CLEARFIELD CITY PLANNING COMMISSION MEETING AGENDA

SUBJECT: Discussion and Possible Action on **FSP 2021-020028**, a final subdivision plat request by Spencer Barber for a 14-lot single-family subdivision at the subject location. **Location:** 245 North 1000 West (TIN's: 12-024-0017 & 12-024-0018). **Total Parcel Area:** 3.16 acres. **Zone:** R-1-6 (Residential). **Planner:** Brad McIlrath (Administrative Action).

Attn: Brad McIlrath, Senior Planner
Proj: **Woods Court Subdivision**
Subj: Plat and Improvement Drawing Review #2

CE1-01

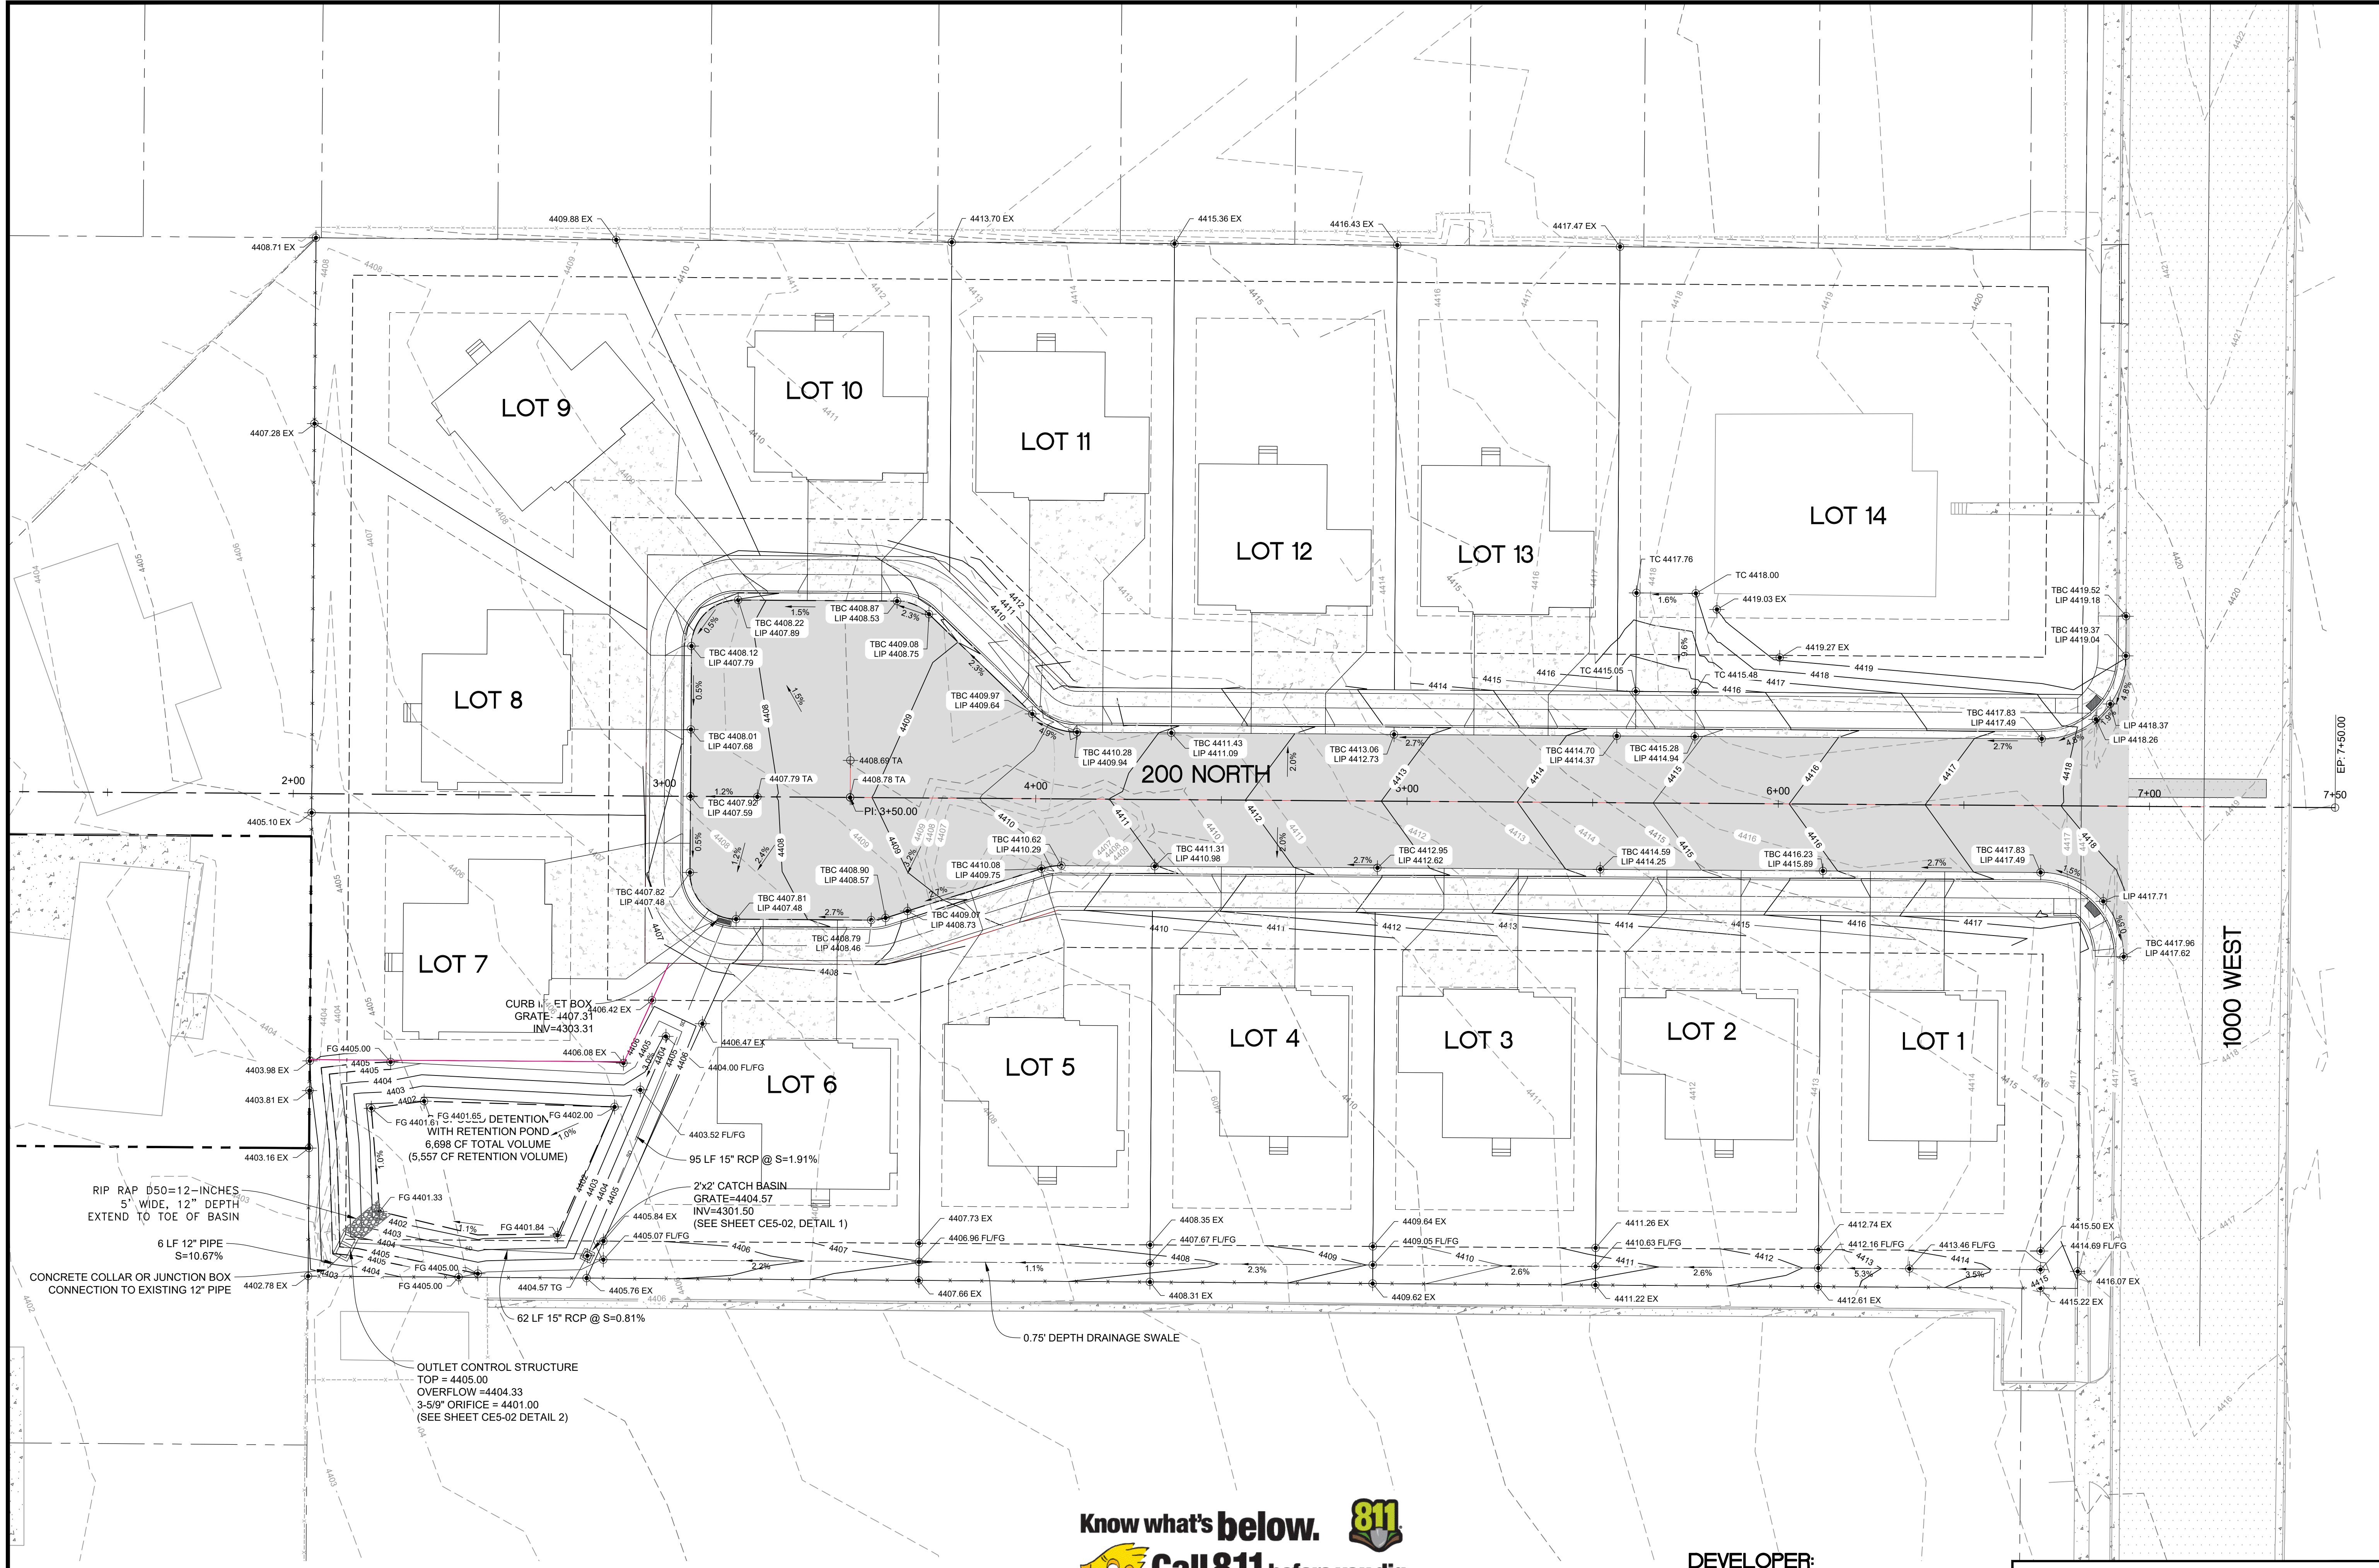
Grading Plan – Sheet CE1-02

1. The 15" diameter storm water pipe will need to terminate approximately 25' East of the outlet control structure (the 15" pipe cannot be connected to the orifice control box directly). At the end of the 15" diameter storm water piping a flared-end pipe outlet with an animal grate will be required. The detail on sheet CE5-02 will also need to be modified.
2. Extending from the flared-end outlet pipe the basin floor will need to be protected from erosion and from storm water scour, with rip-rap (4" to 6" diameter) and drainage fabric beneath the rip-rap. The rip-rap area downstream of the outlet pipe should be at minimum approximately 10' x 25'.
3. The 12" basin freeboard berm should also be identified around the outlet structure and basin walls with notes on the drawings.

CE2-01

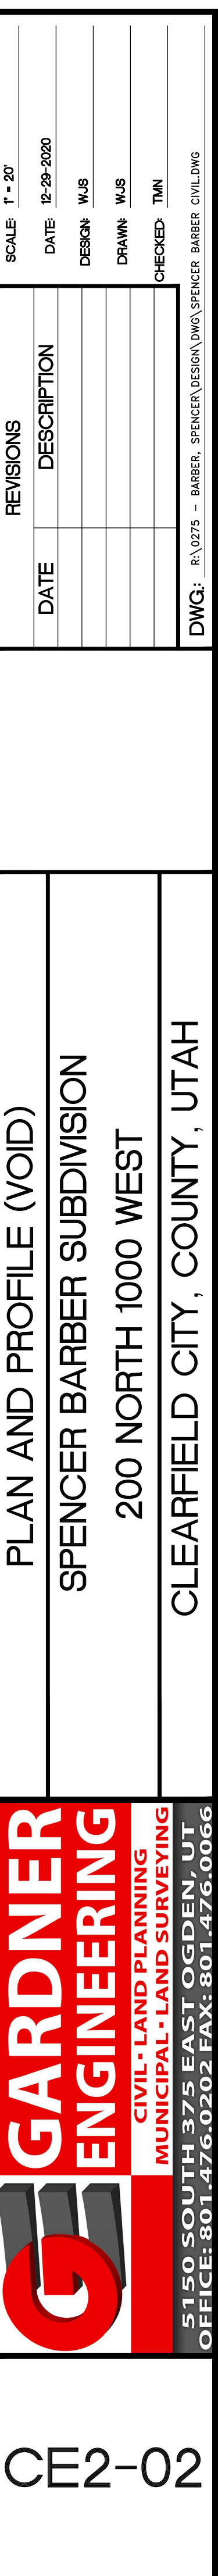
Utility Plan – Sheet CE2-01, CE2-02 and CE5-02

1. The plan and profile utility sheets will need to be revised and finished and then submitted for review. The drawings submitted were an earlier version with “VOID” printed on the drawings.
2. The Geotechnical Engineer will need to conduct **soil percolation tests** in the detention basin area and submit the written results of his tests in an addendum to his Geotechnical Engineering Studies . The results will also need to be added to drawing sheet CE5-02.
